Freeport-McMoRan Chino Mines Company – Administrative Order on Consent
Response to New Mexico Environment Department Comments dated June 24, 2011
Draft Feasibility Study (FS) Proposal for the Smelter/Tailing Soils Investigation Unit
August 11, 2011

This document presents Freeport-McMoRan Chino Mines Company's (Chino's) response to comments from the New Mexico Environment Department (NMED) on the Draft Feasibility Study (FS) Proposal for the Smelter/Tailing Soils Investigation Unit (STS IU) dated May 5, 2011. The comments were received from the NMED in a letter dated June 24, 2011. The draft FS proposal was prepared in accordance with the Scope of Work associated with the Administrative Order on Consent (AOC) between Chino and the NMED. The FS Proposal has been revised to address NMED comments, and resubmitted with this response document. This document is organized to present a response to each comment received from NMED. Comments from NMED's June 24, 2011 letter are reproduced below in bold text, followed by Chino's response to each comment in italics.

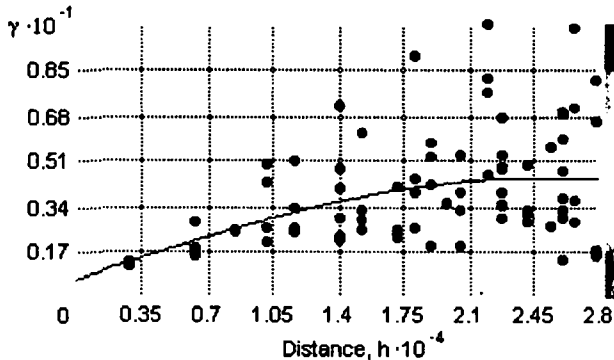
84. **Appendix A, Section A4.2: relating to the first paragraph of Part 1. A statistical interpretation of the data must be provided to justify the use of the ratios in the assessment if the 0 - 1" data are to be used in the assessment. A simple statement of the median relationship is not adequate to support the decision.**

Although the FS Work Plan previously mentioned the use of “average” or “spatially weighted average” this language was inexact and we are not proposing to calculate an “average” concentration per polygon. Our approach involves a statistically supported Kriging method which predicts pCu based upon observed data, as described in more detail below. This approach is supported based on previous consideration of pCu in the Site-Wide ERA (Newfields, 2006).

Based upon Figure 2.5-6 “Total Copper Concentration vs. Soil pH for given pCu2+” in the Site-Wide ERA (Newfields, 2006), total copper and pH covary and copper concentrations are shown to be on a gradient with decreasing concentration with distance from the smelter considering the predominant wind direction. While pH does not always follow the same pattern as copper, particularly due to the variable buffering capacity of site soil, pCu tends to follow the strong spatial gradient of total copper. The Site-Wide ERA says community parameters appear to be correlated with average pCu conditions (Newfields, 2006, page 2-22). The management endpoint documented in the Site-Wide ERA indicates that plants support habitat for wildlife and livestock, and the pre-FS RAC for birds is based upon a population endpoint. Based upon the conclusions of the Site-Wide ERA, the pCu threshold of 5 protects plants from being reduced in size (emergence is not affected until much lower pCu) or protects plant communities from shifts in species composition. Reduction in plant size or shifts in species composition are less of a threat to the wildlife populations because the prey base can still exist upon smaller plants and wildlife can continue to forage upon this prey base. Therefore an average pCu is protective of plants that support habitat for these populations.

After investigating the current dataset, Chino found that the data lend themselves to use of a statistically sound and rigorous Kriging model that minimizes estimation error. Such a model depends on the site having a strong spatial gradient in pCu (driven primarily by the total copper gradient) and high autocorrelation. The current pCu dataset creates a good semi-variogram (Fig. 1), showing high spatial autocorrelation up to 20 km. This means nearby points are more similar than points far apart as expected if pCu is decreasing with distance from the smelter and tailings ponds. Thus, Chino proposes this Kriging technique for interpolating pCu, which allows statistical evaluation of the error, and reduces sampling

effort because it should be able to predict areas unsampled with reasonable accuracy. We will modify Section A8.1 of the FS Proposal to show this analysis and choice of Kriging as the interpolation method for pCu. In addition, the sentence on page A-18 that says, "The spatially-weighted average..." will be modified to say that "the estimated pCu concentration represented by the area within the Kriged boundary of pCu<5 will be used to screen exposure unit polygons." In other words, rangeland polygons that intersect the pCu<5 contour line will be those evaluated for remedial alternatives. While it does not technically represent a lower confidence limit (LCL) on the mean because it does not take into consideration a standard deviation, the fact that estimation error is minimized by the underlying Kriging algorithm and a spatial gradient with high autocorrelation, the "average" concentration within the Kriged boundary is appropriate for this level of analysis to support an evaluation of FS technologies and remedial alternatives.
